**Development of Draft Construction Safety
Standards for Excavations. Volume 2**

(U.S.) National Bureau of Standards
Washington, DC

**DEVELOPMENT OF DRAFT CONSTRUCTION
SAFETY STANDARDS FOR EXCAVATIONS**

Volume II

Figure 4. Components of the Shoring System

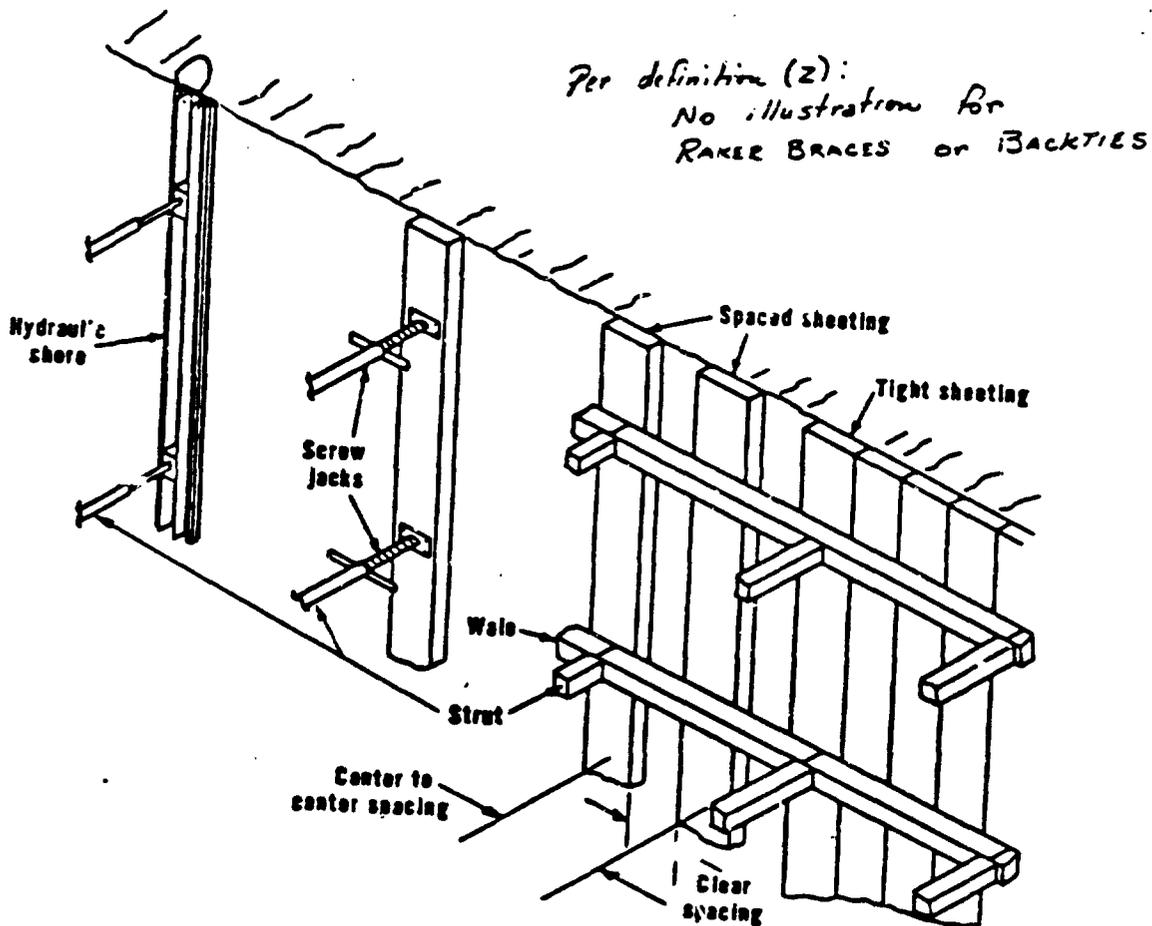
- ✓ (w) Spaced Sheeting is sheeting in which the members bearing against the excavation wall are spaced (see Figure 6). *Figure 4?*
- ✓ (x) Spalling is the continuous flaking and falling of soil or rock from an unsupported trench wall.

- ✓ (y) Standard Practice is the trenching and shoring practice in Section 1926.652 (b).
- ✓ (z) Struts are the primary support members of a shoring system including but not limited to cross braces, raker braces, jacks and backties (see Figure 6) *Figure 4?*

Raker braces or backties are not illustrated
